3 Leverton Place

Response to revised planning Application 2016/1088/P

From Deborah Cook occupant at 9 Leverton Street, London NW5 2PH

Figure 7. Section through 7 Leverton Street and the rear extensions of 3 Leverton Place showing impact of the proposed additional extensions on daylight and sky horizon.

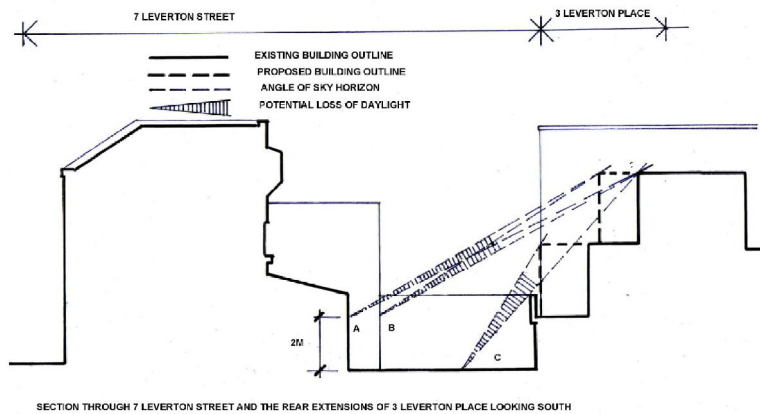
Taking the impact of the planning application on the house and garden of 7 Leverton Street first, this house and garden is overshadowed for nearly two thirds of its width by the three storey flank wall of 3 Leverton Place. The angle of the sky horizon from the rear window of 7 Leverton Street to the roofline of 3 Leverton Place is 45 degrees. Just over a third of the garden of 7 Leverton Street is overshadowed by the rear extensions on the back of 3 Leverton Place. Here again the angle of the sky horizon is very steep and would be made even steeper by the proposed rear extensions to 3 Leverton Place if this application is approved, see figure 7.

The proposed rear extensions would lead to a loss of daylight to the ground floor windows of 7 Leverton Street at A and B on the diagram. They would also lead to loss of daylight across the garden of 7 Leverton Street between the back of the house and the point at which the existing rear extensions cut off the daylight horizon at C on the diagram. Given that this garden is already severely deprived of sunlight and daylight and additional loss would be unacceptable.

Figure 8. Section through 9 Leverton Street and 3 Leverton Place showing impact of proposed screening to the proposed 1st floor roof terrace at 3 Leverton Place on daylight and sky horizon.

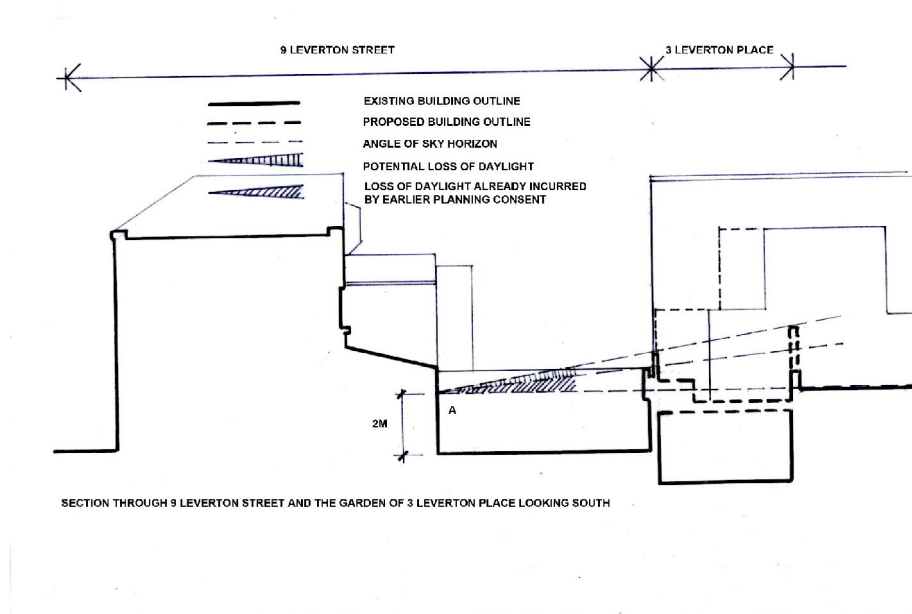
Looking now at the potential impact of the current application on my house and garden at 9 Leverton Street, figure 8 shows that the screen of the proposed first floor roof terrace behind 3 Leverton Place would significantly raise the daylight horizon from my kitchen window at A. This would extend the full width of my garden. The diagram shows that the sky horizon was already raised significantly by the introduction of a fence on top of the garden wall to reduce overlooking from the first floor terrace behind 2 Leverton Place, approved in 2000. Because 1, 2 and 3 Leverton Place already cuts out most of the south west sunlight and daylight from my garden, the additional reduction in daylight caused by this proposal, if the application is approved, would be very detrimental.

Figure 10. Can you tell, without the titles, which is the existing and which the proposed elevation?

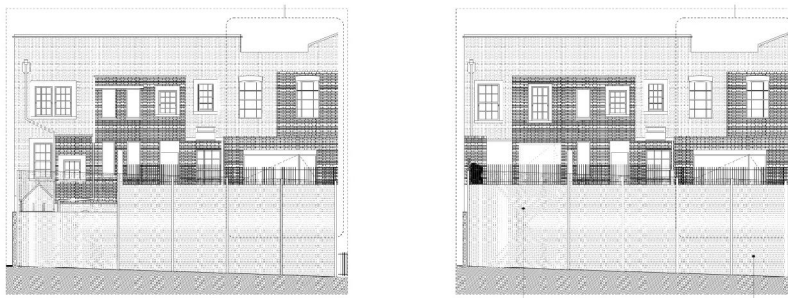
A good deal of effort has been expended in the applicant's Design and Access Statement in presenting the changes to the rear elevation as improvements to the conservation area. The claim is that the proposed extensions to the rear elevation of 3 Leverton Place improve the massing and composition of the rear elevation of 1 – 3 Leverton Place. Looking at the before and after drawings of the elevation on application drawing NMA 15 02 100 it is very hard to say which is the more authentic or appropriate?

This is because the extensions are desired primarily to provide more internal floor space and the presentation of these changes as enhancements to the conservation area is a transparent attempt to divert attention from the fact that they benefit no-one except the applicants and would impact negatively on neighbouring properties. I have no objection to any tidying up of the elevation of 3 Leverton Place just as long as this does not involve further extensions to the existing building that causes further overshadowing of the adjacent gardens and houses on Leverton Street. I note that CPG 1 states that *"In most cases, extensions that are higher than one full storey below roof eaves/parapet level, ... will be strongly discouraged."* One of the proposed extensions is to the top floor of 3 Leverton Place.
